# Connecting Palo Alto Projects

## Caltrain Technical Review

# Vertical Alignment (Correction)

**Meadow Charleston - Hybrid**

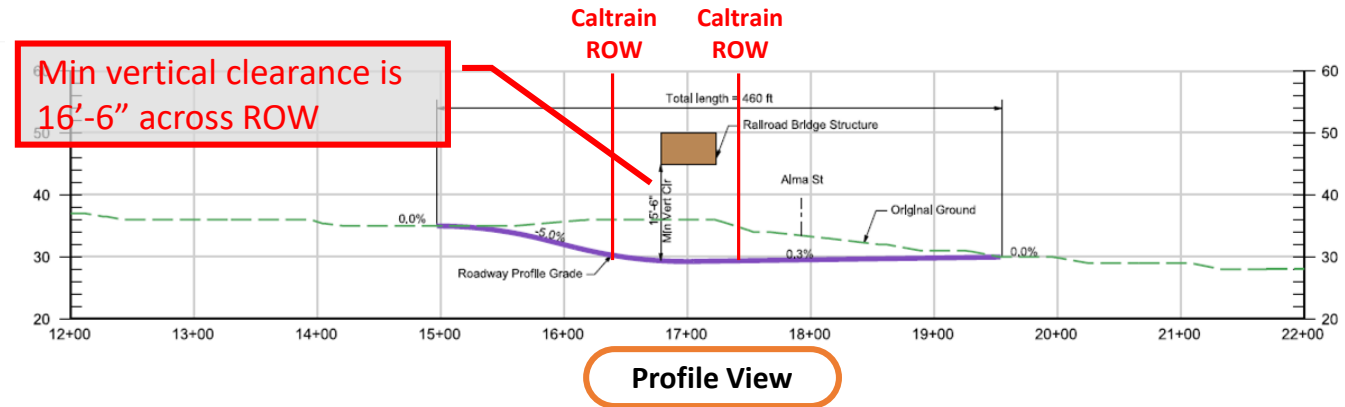
- Vertical Clearance for vehicular traffic under the Railroad (Increase from 15.5' to 16.5')

**Meadow Charleston - Viaduct Alternative**

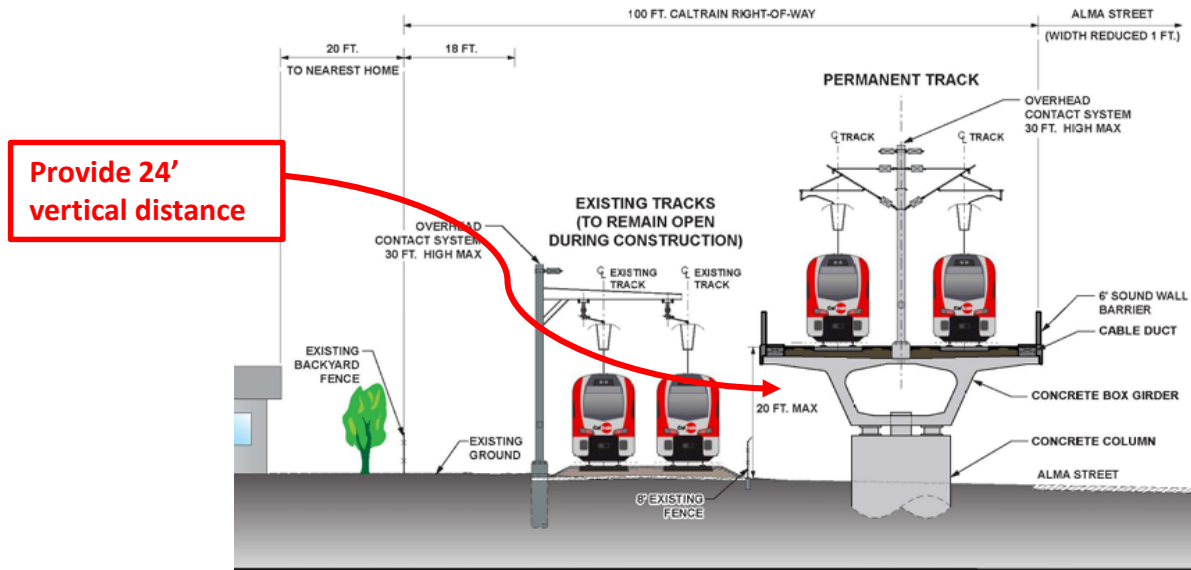
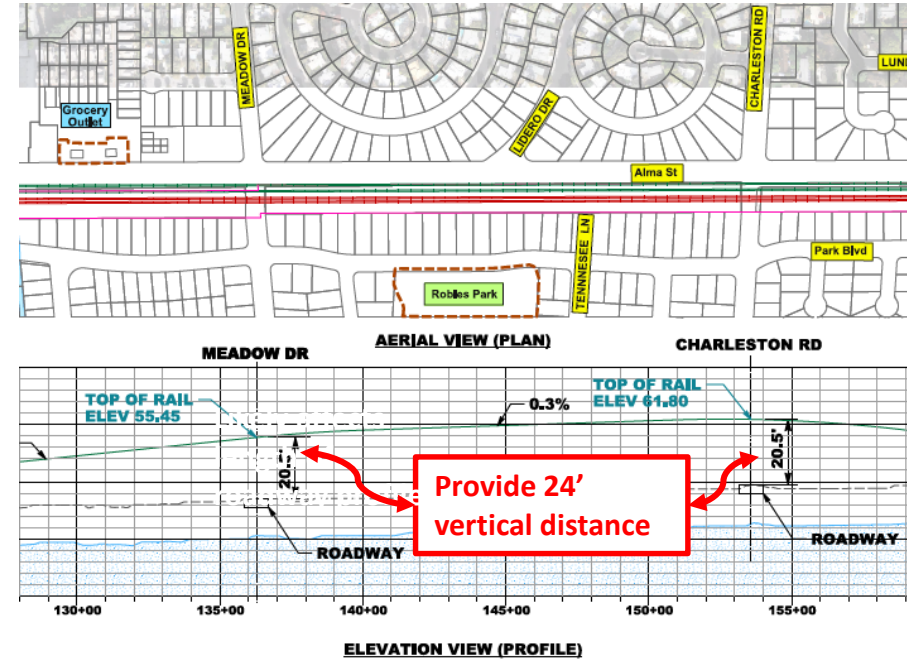
- Vertical Clearance for vehicular traffic under the Railroad (Increase from 20.5' to 24.0')

# Summary of Comments - Churchill Avenue – Closure Option 1

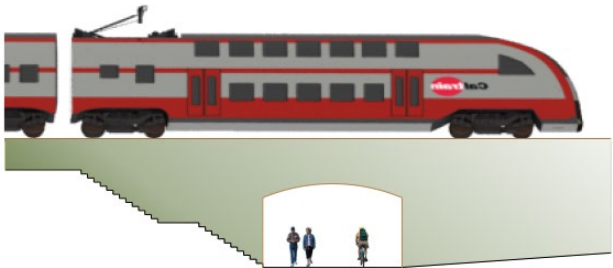
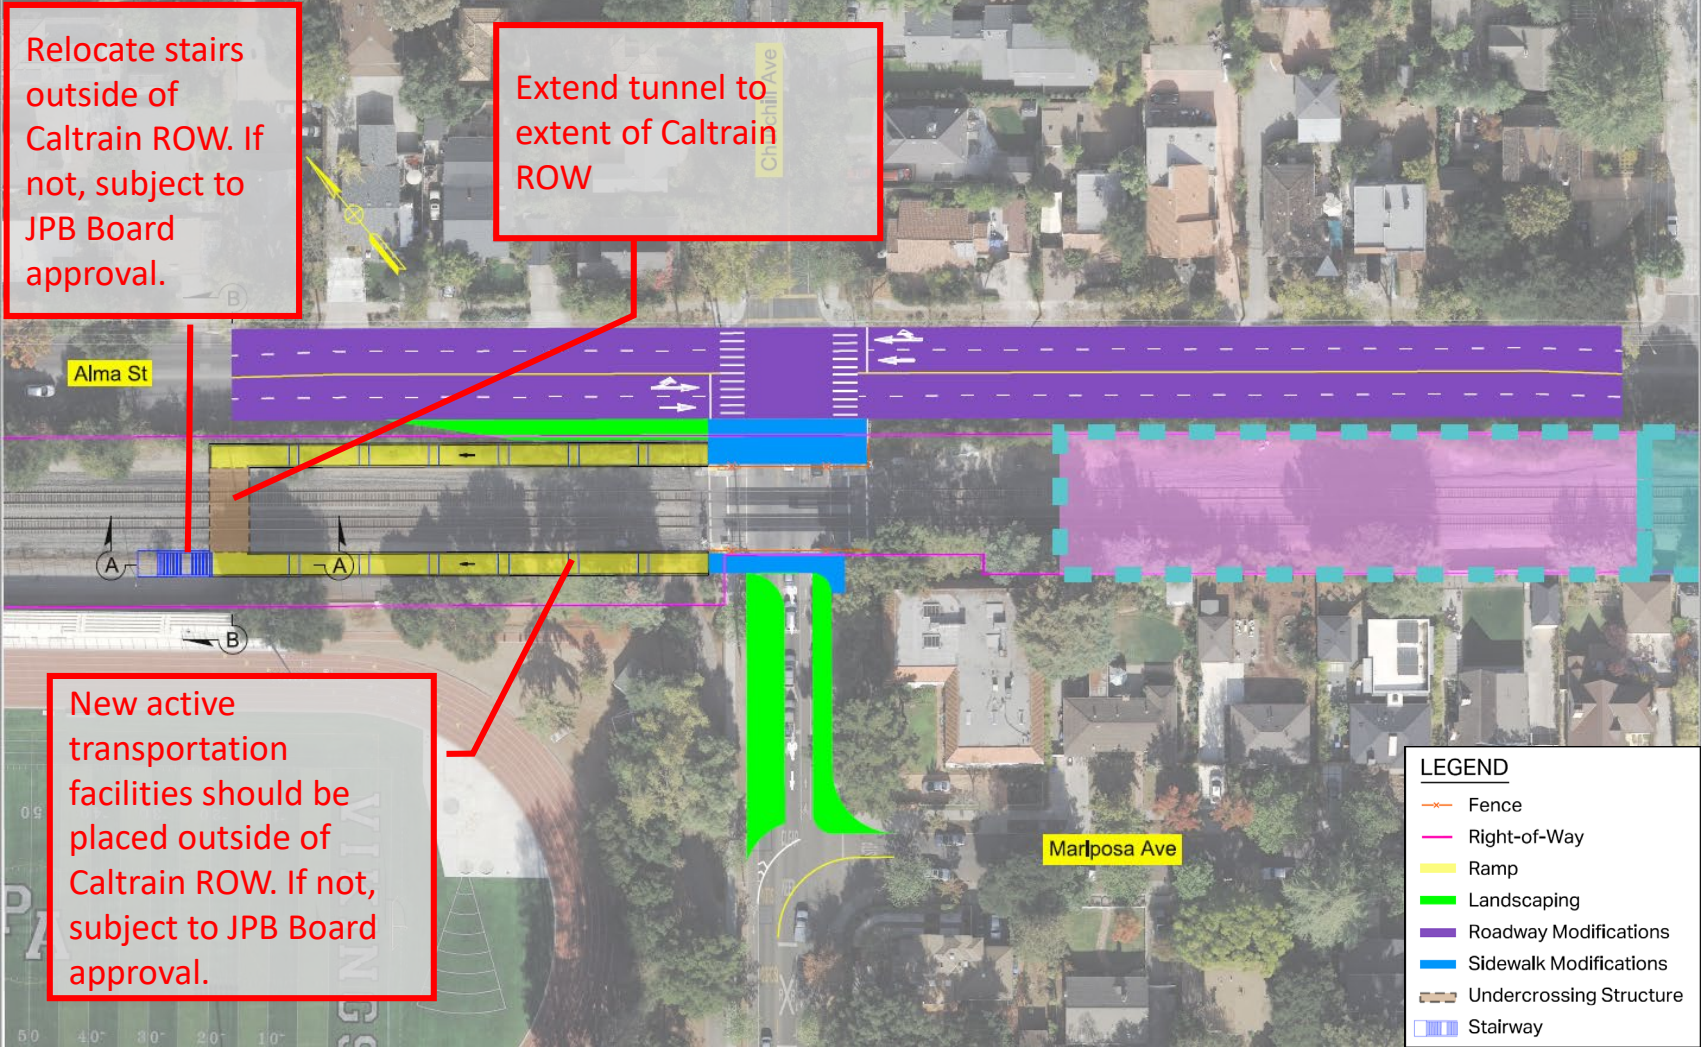
- 4-Track Influence Area
- Transition between 2-Track and 4-Track

# Summary of Comments - Churchill Avenue – Partial Underpass

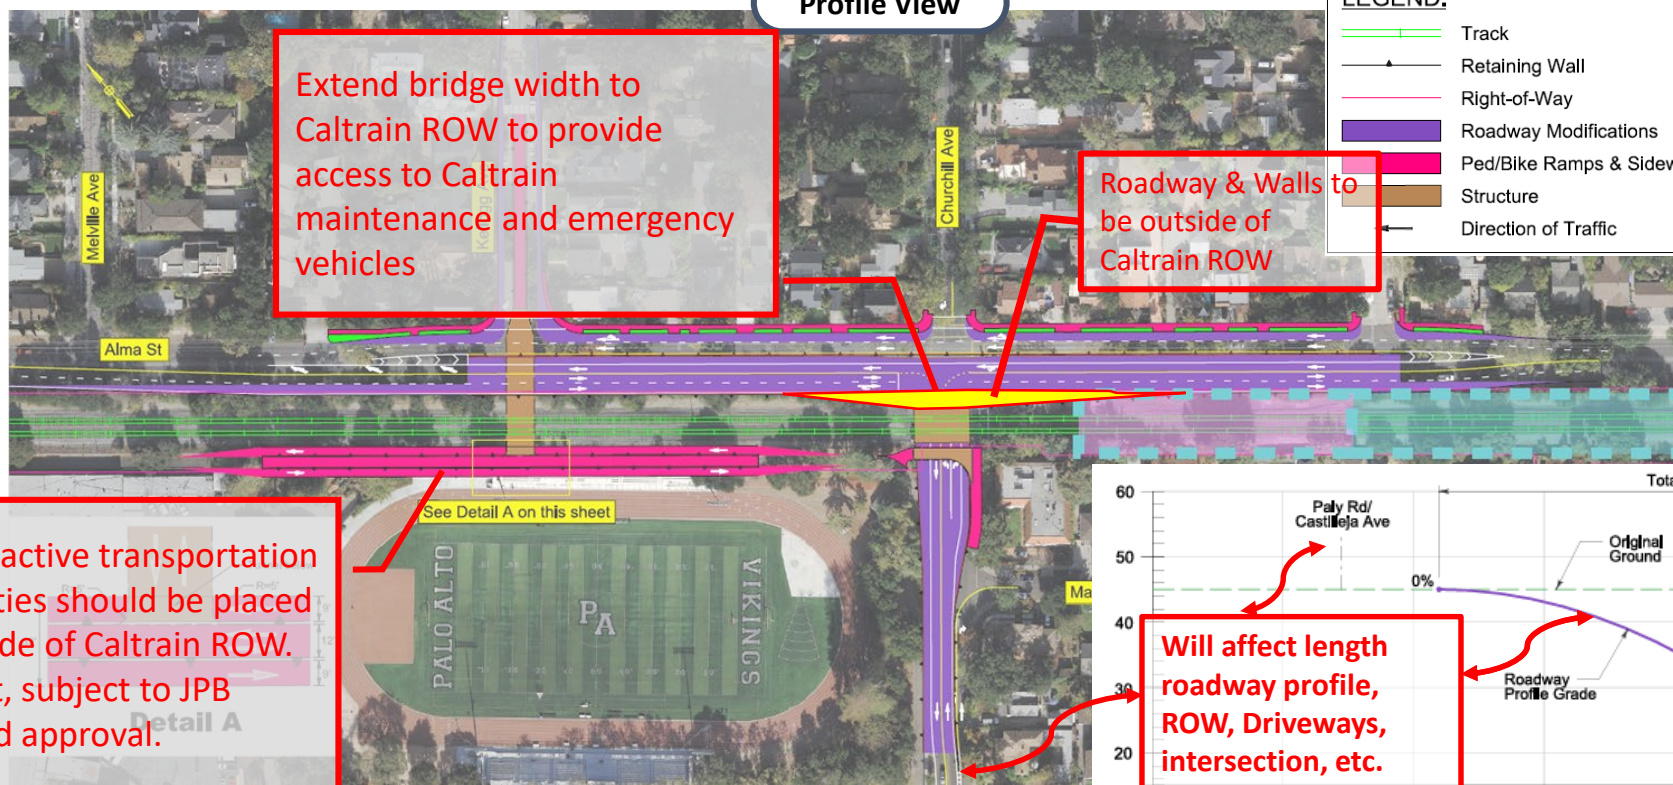
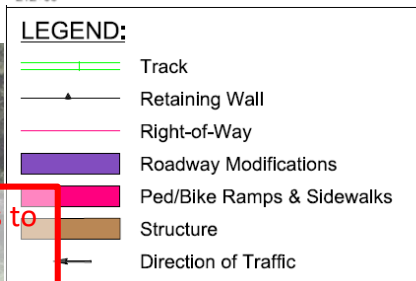
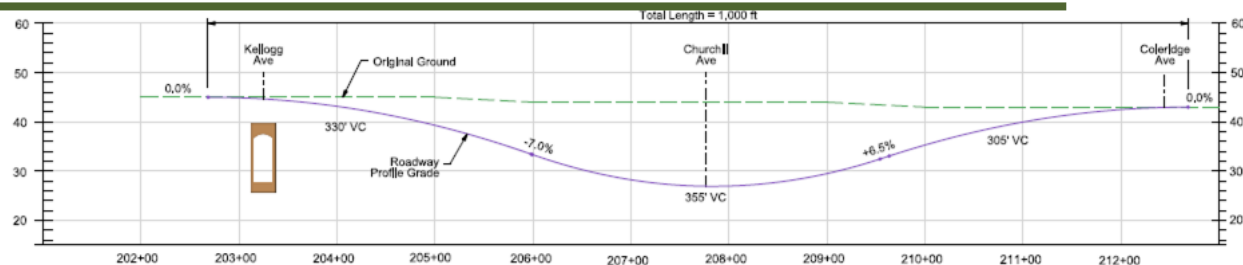
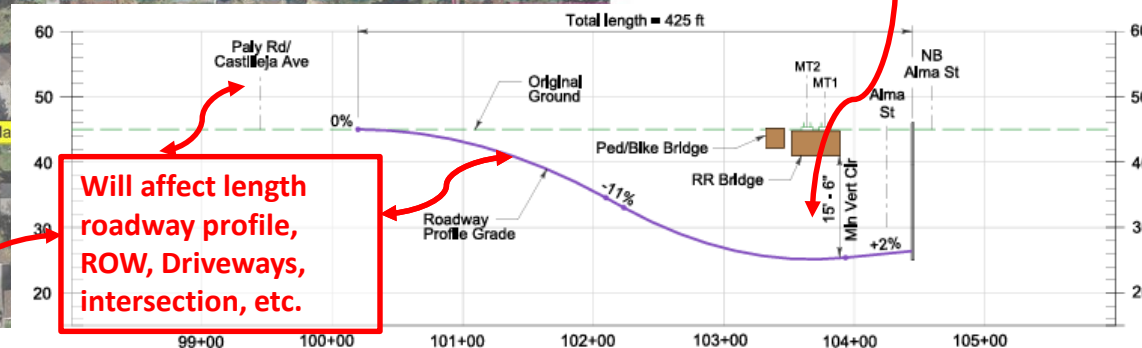
Extend bridge width to Caltrain ROW to provide access to Caltrain maintenance and emergency vehicles

Roadway & Walls to be outside of Caltrain ROW

Provide 16'-6" vertical clearance

New active transportation facilities should be placed outside of Caltrain ROW. If not, subject to JPB Board approval.

Will affect length roadway profile, ROW, Driveways, intersection, etc.

- Merging taper/median design
- Offset from barriers
- Lane width etc.
- Curved bridges

## Plan View (Meadow Drive)

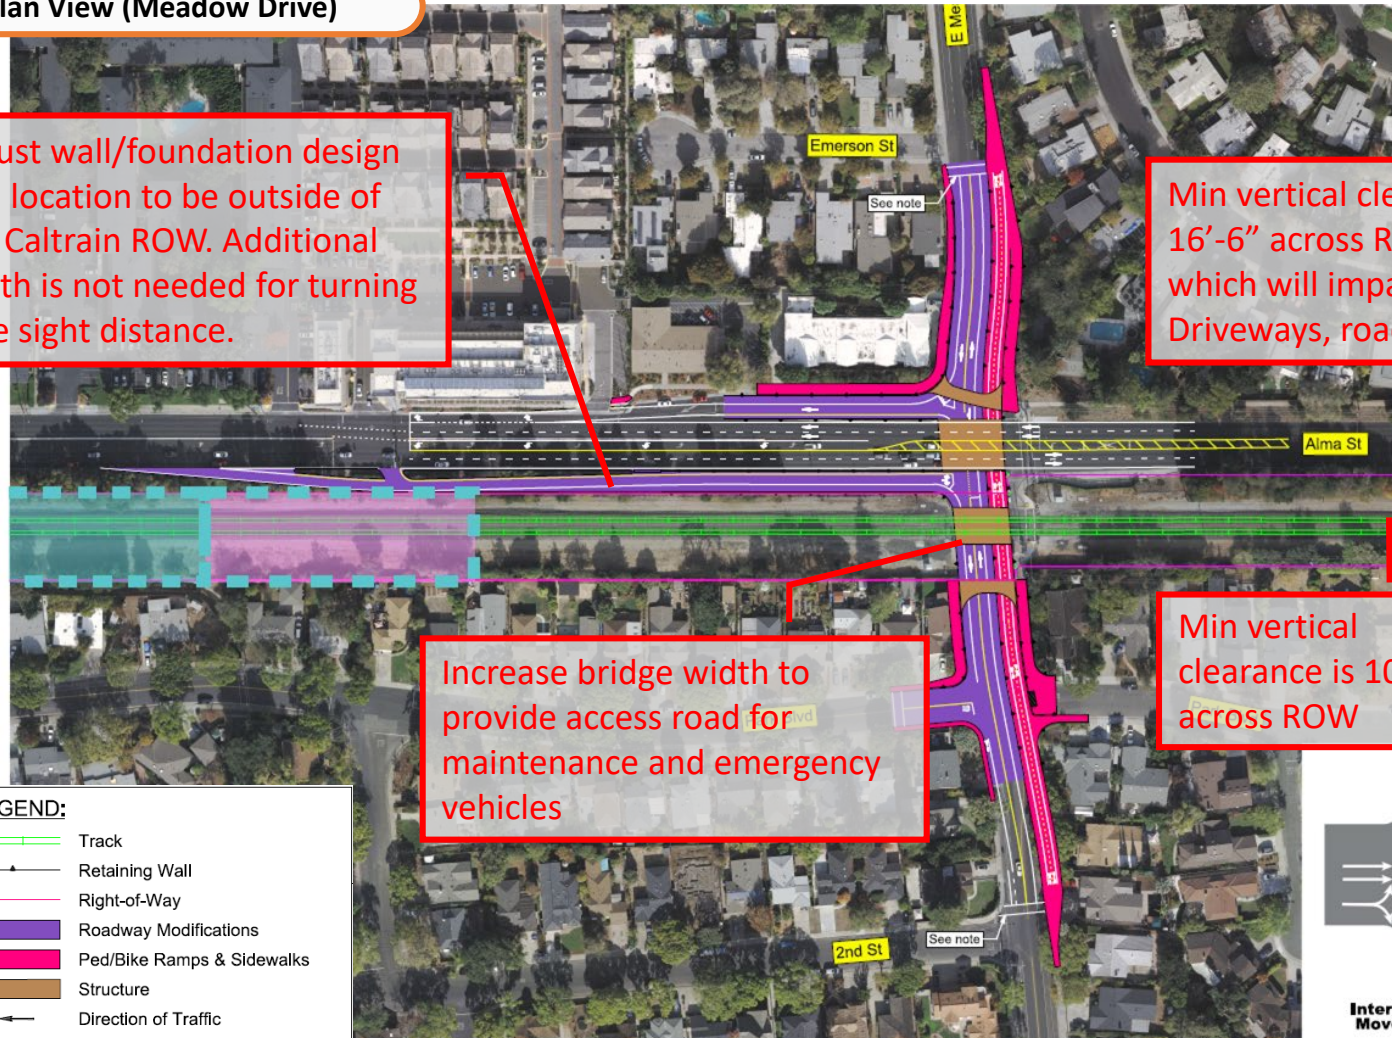
Adjust wall/foundation design and location to be outside of the Caltrain ROW. Additional width is not needed for turning lane sight distance.

Min vertical clearance is 16'-6" across ROW, which will impact ROW, Driveways, road profile.

Increase bridge width to provide access road for maintenance and emergency vehicles

Min vertical clearance is 10' across ROW

**Ped/Bike Profile from Park Blvd to Emerson St**

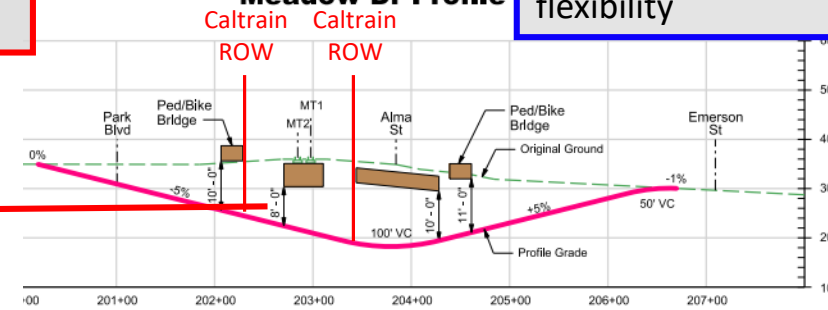
Steep grade limits options for design flexibility

# Summary of Comments – Meadow Dr & Charleston Rd - Hybrid

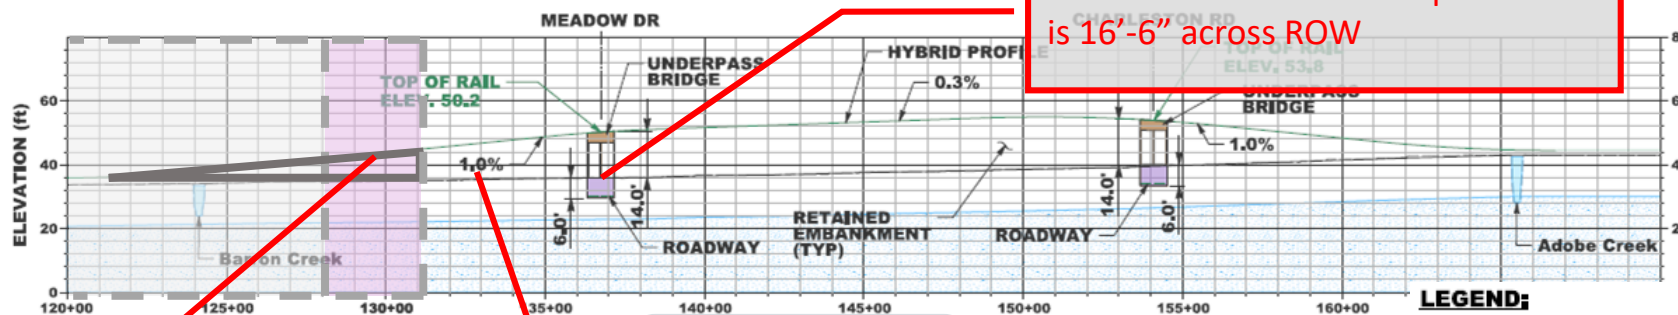
4-Track Influence Area     Transition between 2-Track and 4-Track

Provide additional width on the bridge to accommodate access road for maintenance and emergency vehicles

Fill retaining walls to accommodate 4-track and transition between 2-track and 4-track

Min vertical clearance requirement is 16'-6" across ROW

Design speed is 110 mph for passenger rail

Transition segment should be tangent as special trackwork should stay outside of vertical curves

1% grade is the current maximum without variance. 1% to 2% grade requires review and approval by the Director of Engineering

# Summary of Comments – Meadow Dr - Hybrid

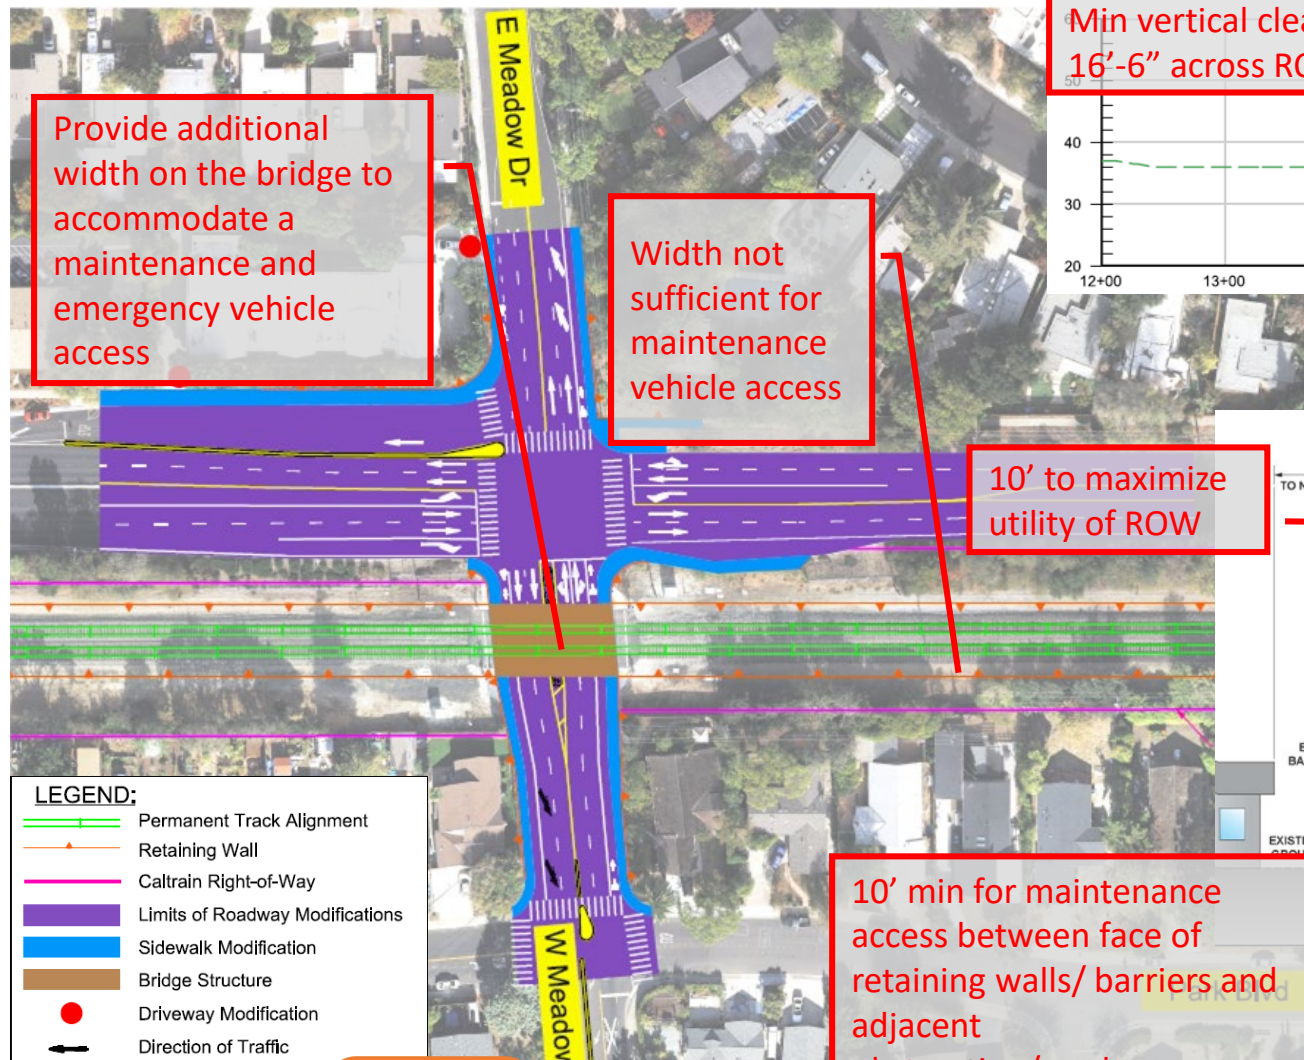
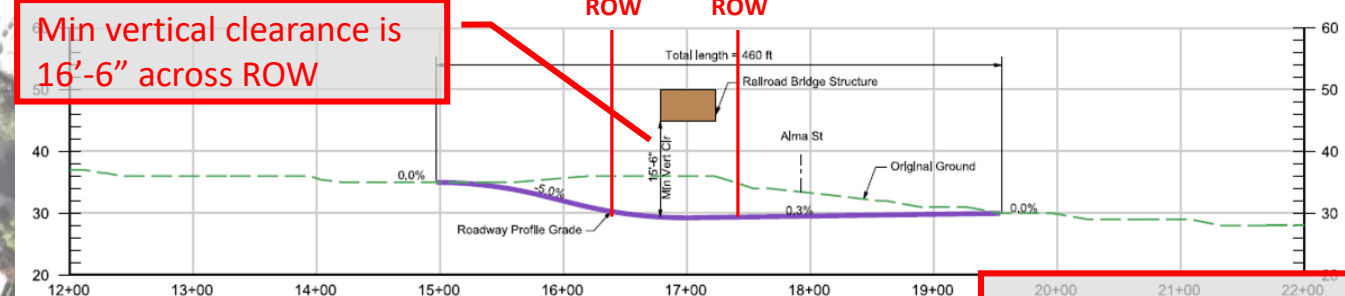
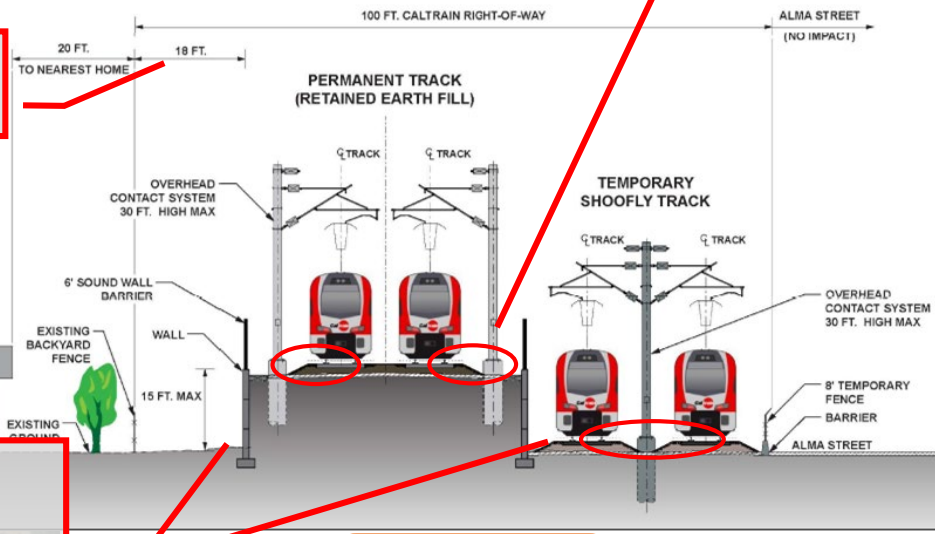
Min vertical clearance is 16'-6" across ROW

Confirm proximity of OCS and centerline of tracks
